ADDENDUM NO. 2

NATICK, MASSACHUSETTS
BOARD OF SELECTMEN

CONTRACT NO. W-144

WATER TREATMENT PLANT BACKWASH TANK

SHEET NO.:	2 OF 6
CONTRACT NO.:	W-144
SCALE:	AS NOTED
DATE DRAWN:	AUGUST 2016
DRAWN BY:	JWG
FILE NO.:	NAT-423-01.DWG

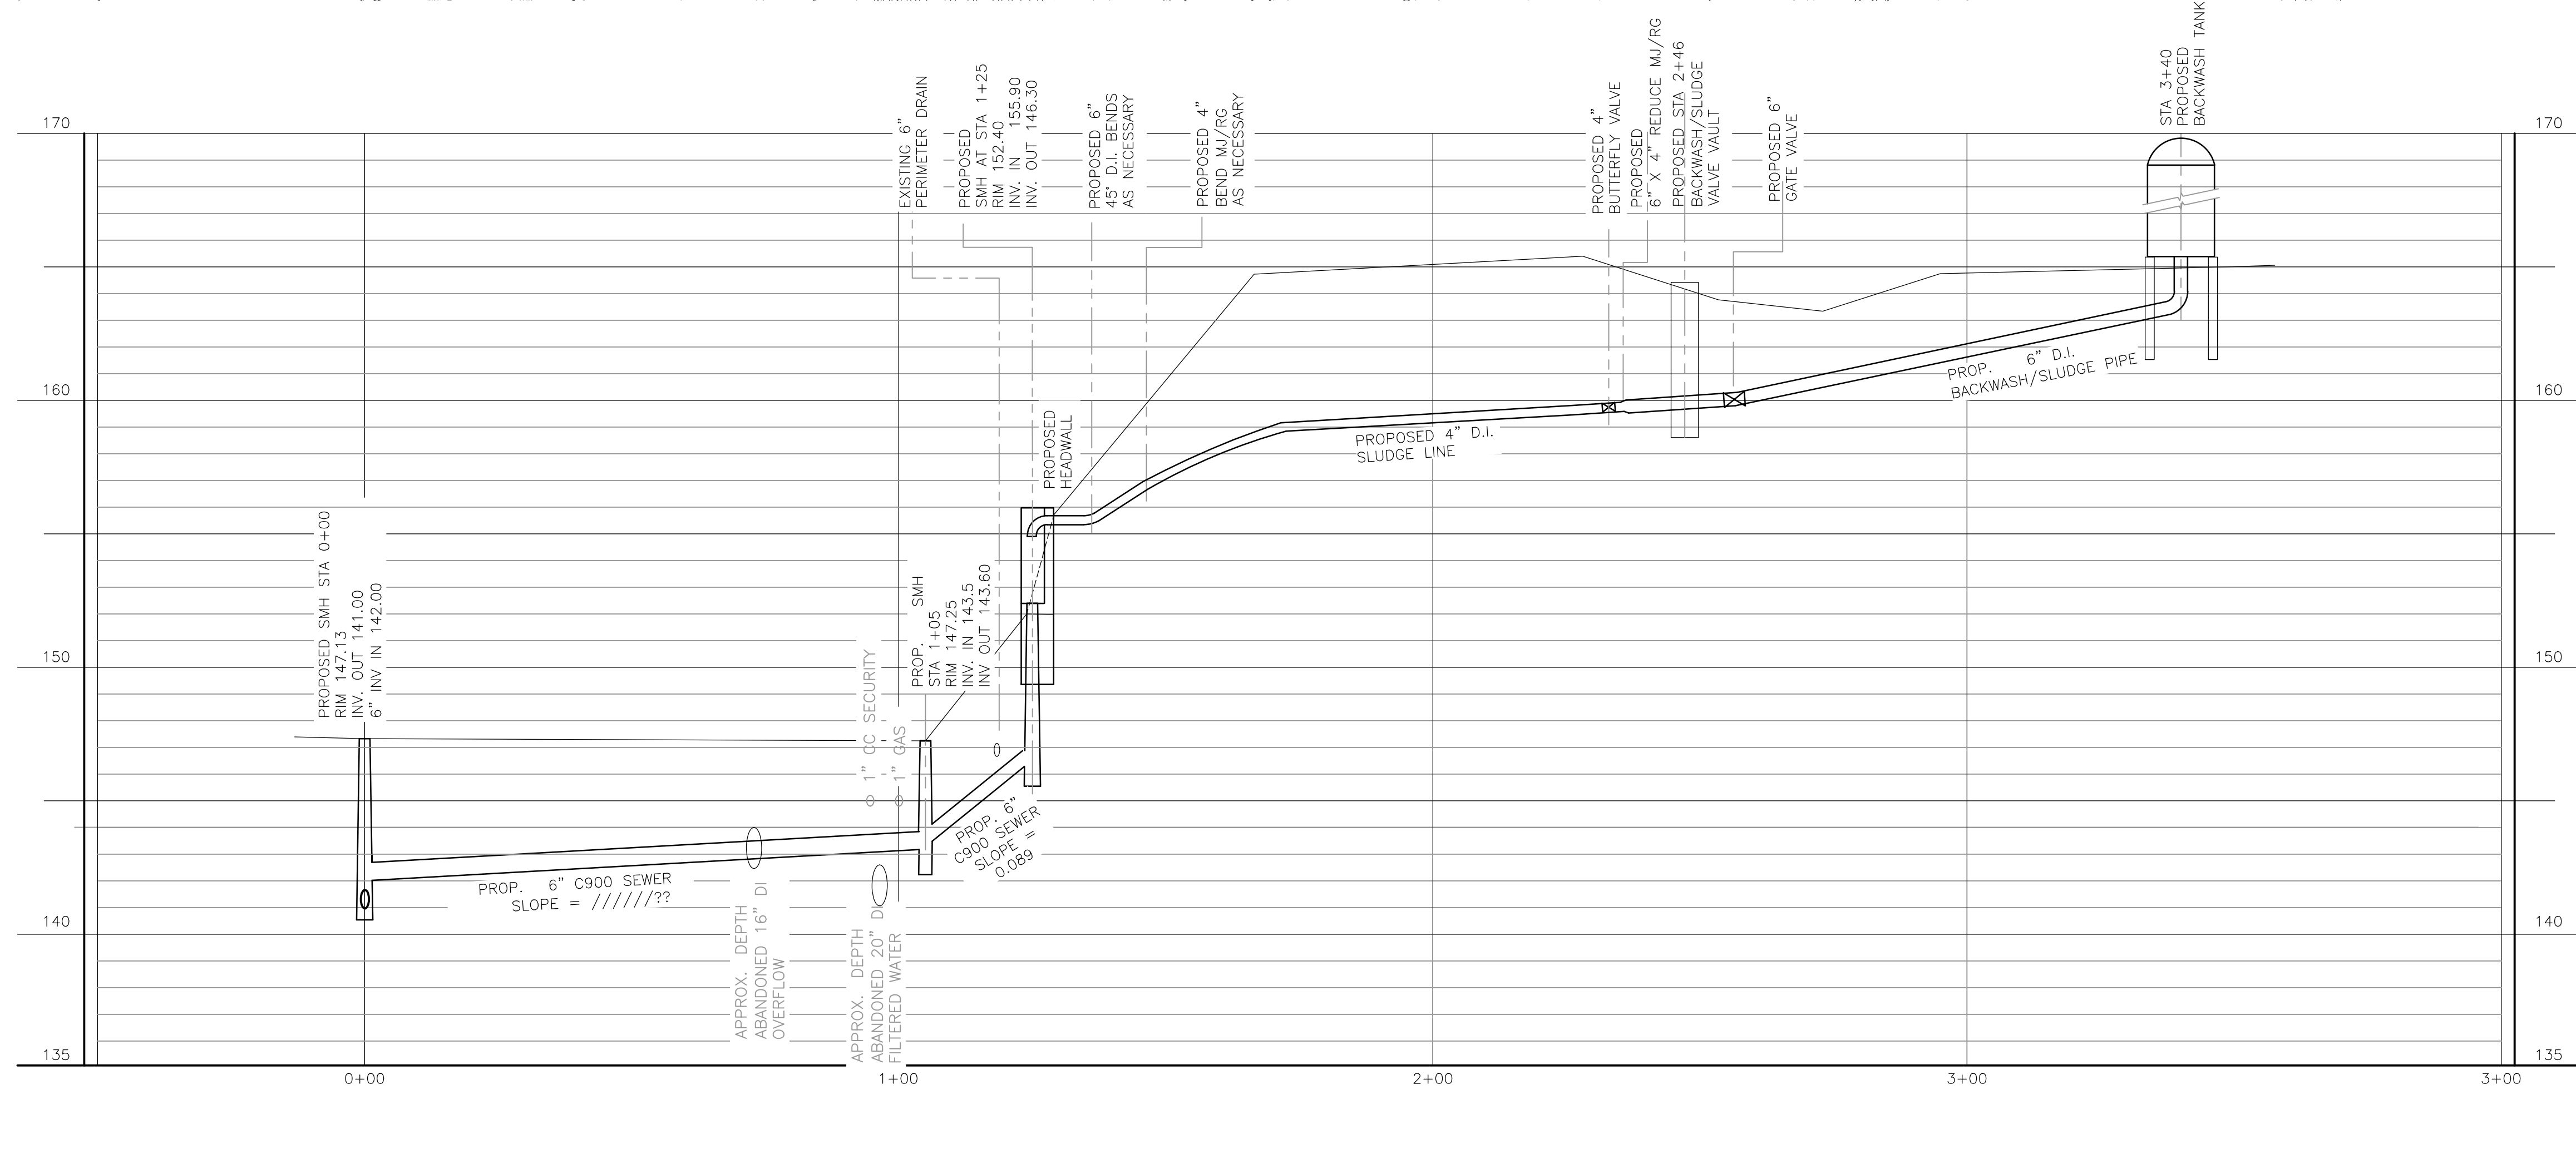
Drawing G1: See attached revised G1 drawing. The revision is the addition of the four (4) boring locations.
